FINAL DRAINAGE REPORT

WALDEN PRESERVE 2 – FILING NO. 4

September 5, 2018
Revised February 26, 2019
Revised May 16, 2019
Revised August 30, 2019

JPS Project No. 040201
PCD File No. SF-18-034

SHEET: **D1**

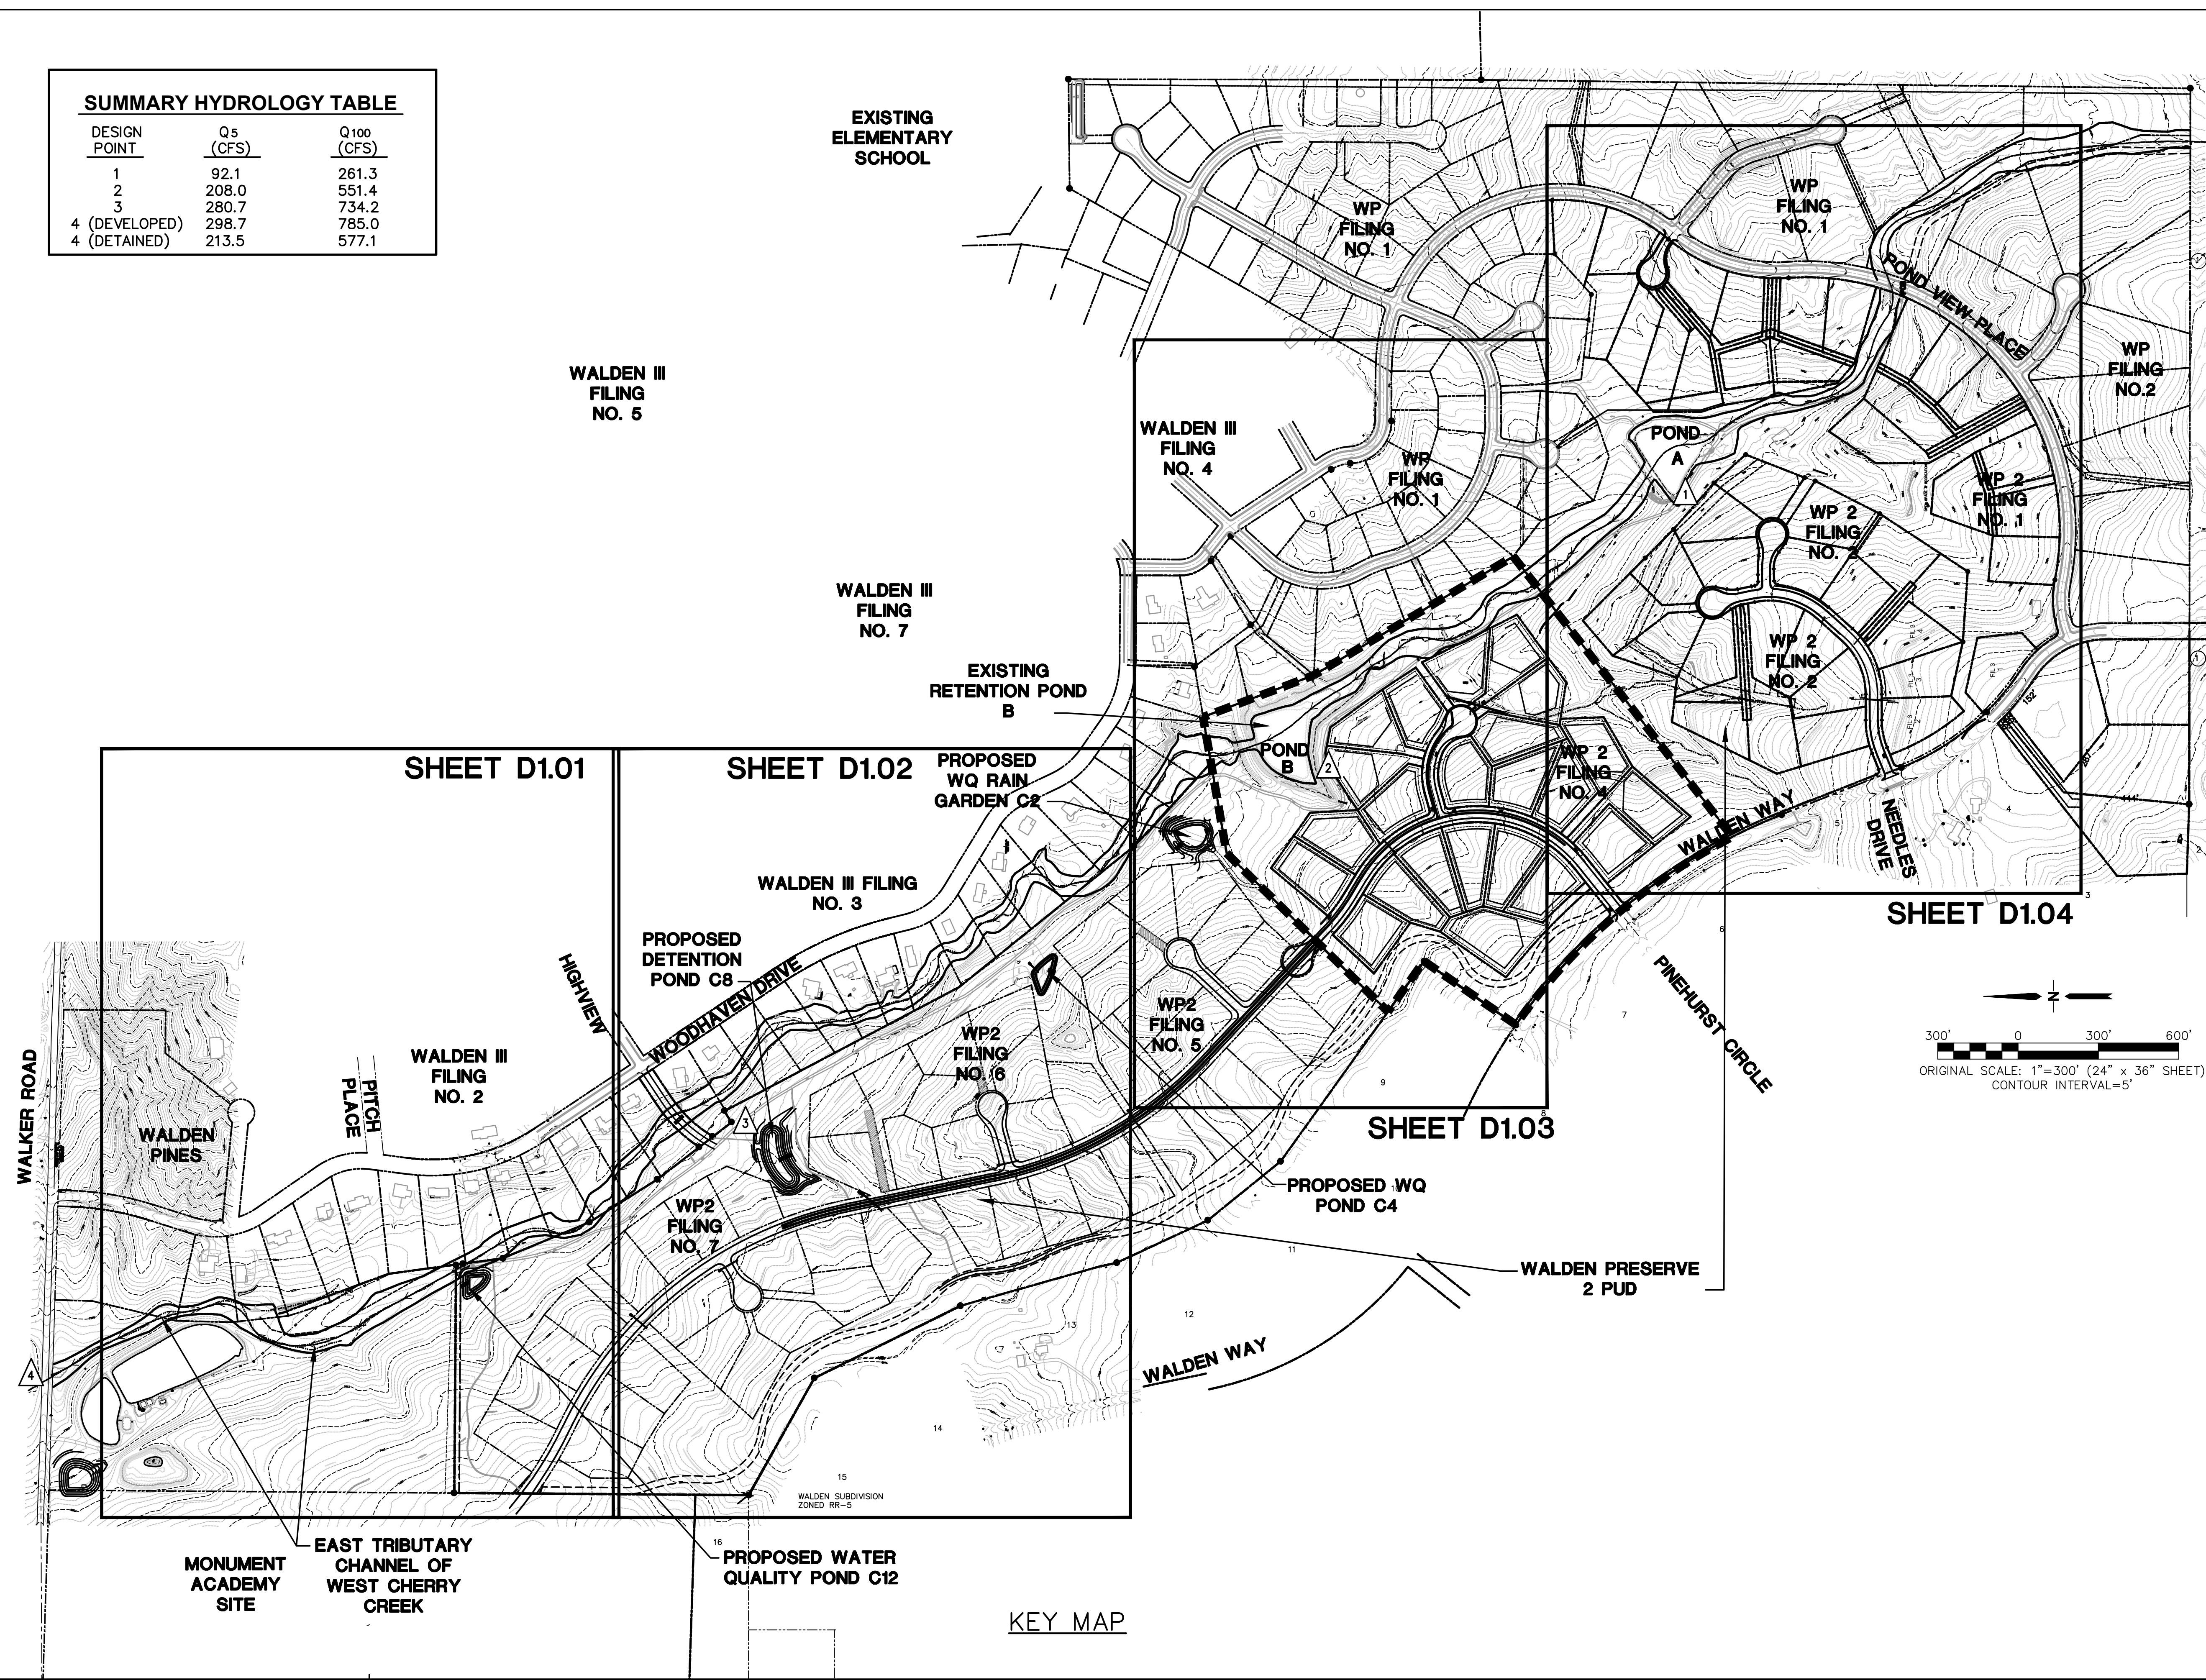
Since Pond B is to be constructed meeting current criteria for FSD, update the table to identify the historic and developed flow for the other storm event to show historic levels are maintained for the other design storms (2-yr, 10-yr, 25-yr, 50-yr, EURV).

Unresolved (Clarification). Since you over detaining at Pond B, the report needs to show that the development is releasing at or below historic at design point 4. Therefore, provide the historic vs developed flow comparison at the ultimate discharge (DP4) for the full spectrum of design storms.
